UPPER UWCHLAN TOWNSHIP  
PLANNING COMMISSION  
AGENDA  
**March 9, 2023**

RE: 301 Park Road – P.J. Reilly Contracting, Inc.  
Proposed Headquarters Building  
Preliminary Land Development Application  
Upper Uwchlan Township  
WAI Project 2021-231

We are in receipt of your review letter dated December 2, 2022 and have the following responses:

**RECORD PLAN SHEET 1 OF 2**

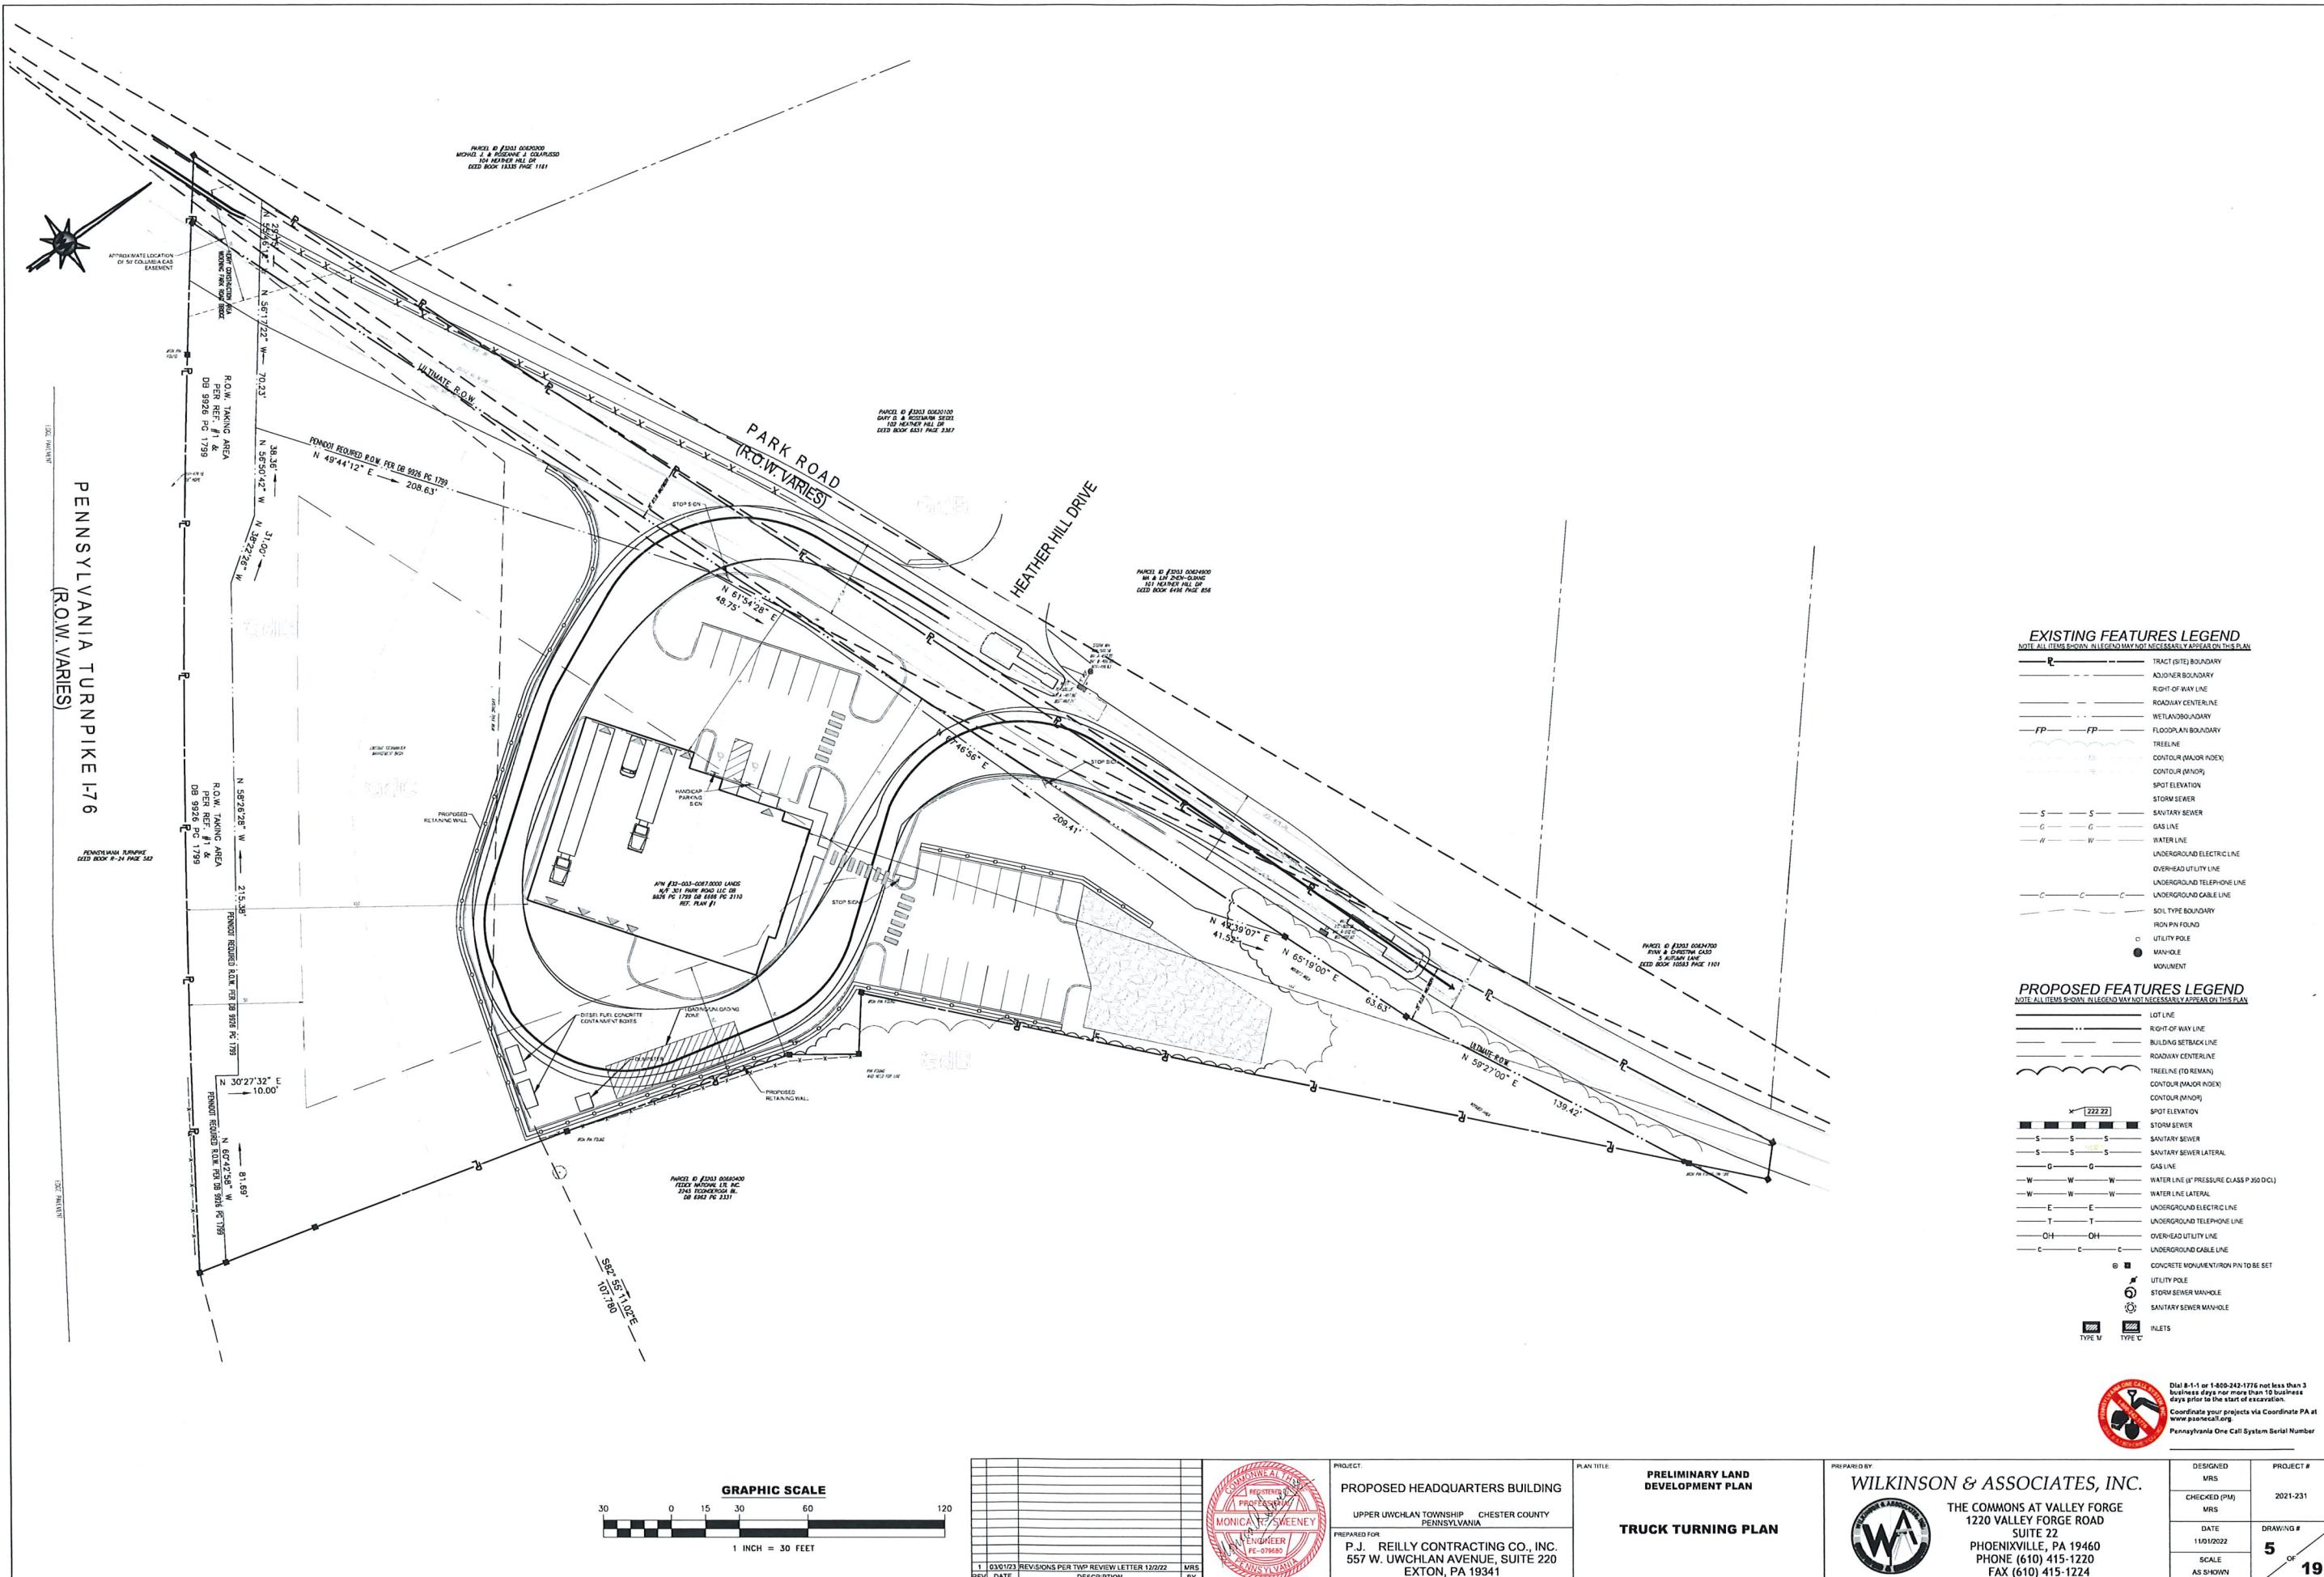
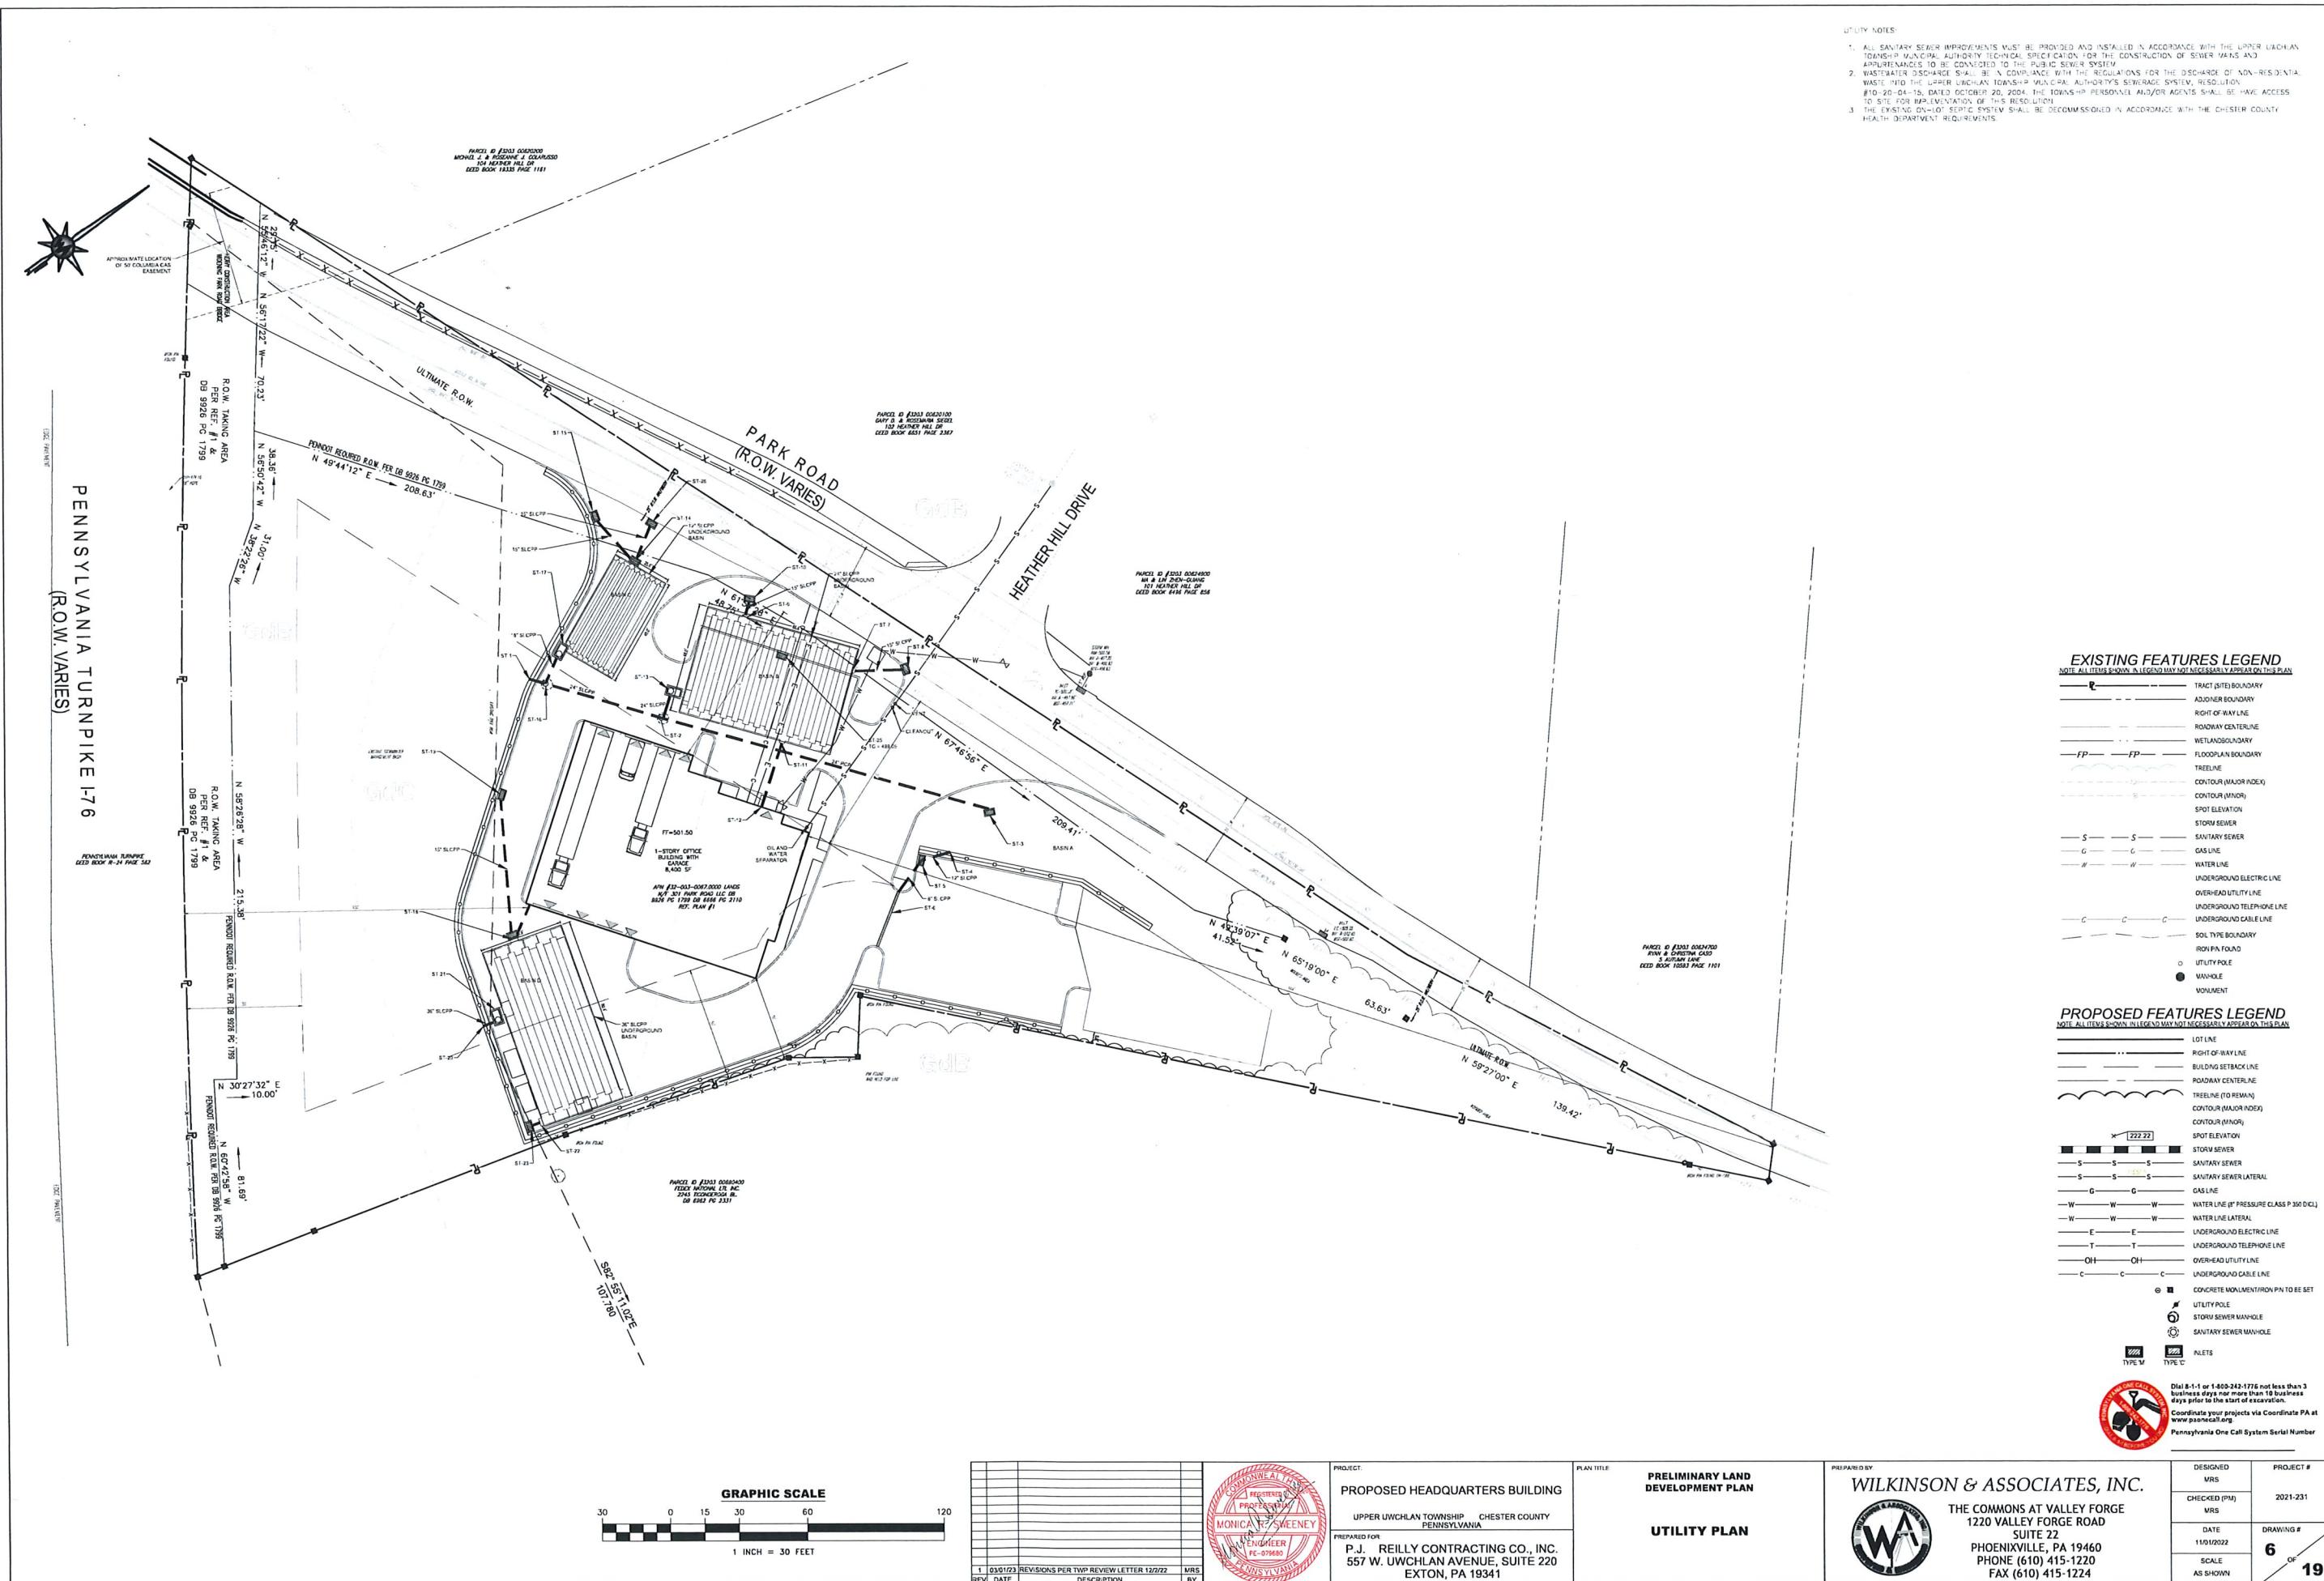
3. Revise the "Site" location on the Zoning Map on Sheet 1, as it pointing to an incorrect location.

6. The location of subject property on zoning insert map on sheet 1 is misrepresented. We strongly encourage correction to avoid any confusion.

*The site location on the Zoning Map on Sheet 1 has been revised.*
